**TOWER 2, LEVEL 23
DARLING PARK, 201 SUSSEX ST
SYDNEY NSW 2000**

16 April 2018

100 MOUNT STREET, NORTH SYDNEY - PROPOSED S4.55(1A) MODIFICATION TO MAJOR PROJECT 08_0241

Figure 1 ĩ Floor Plan

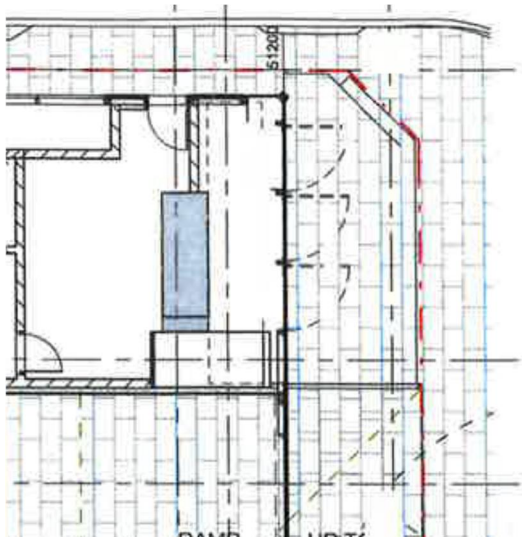
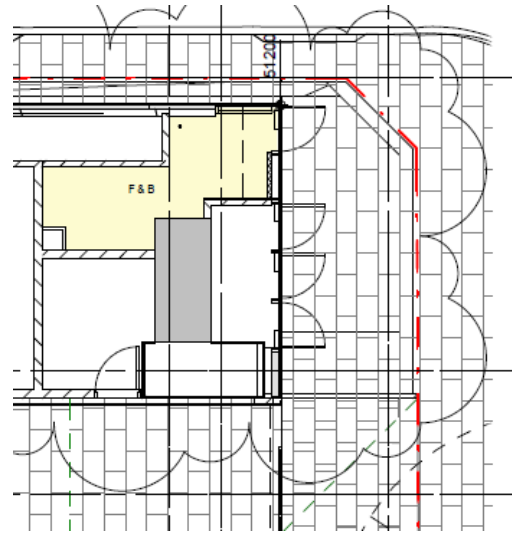
Details of the proposed modification are shown in the plans prepared by Architectus attached at **Appendix A**. The plans are coloured and annotated to identify the proposed development as modified, compared to that approved. **Figure 1** and **Figure 2** compare these graphically.

- Convert an 8.83m² area of unused plant storage to a café for takeaway use only;
- Reconfigure the openings at the north-eastern corner of the building, with minor alterations to the northern and eastern elevations to create the coffeeshop server area; and
- Amend consent conditions A2, B5 and B6 to account for the resultant changes to:
 - the approved architectural drawings; and
 - monetary contributions.
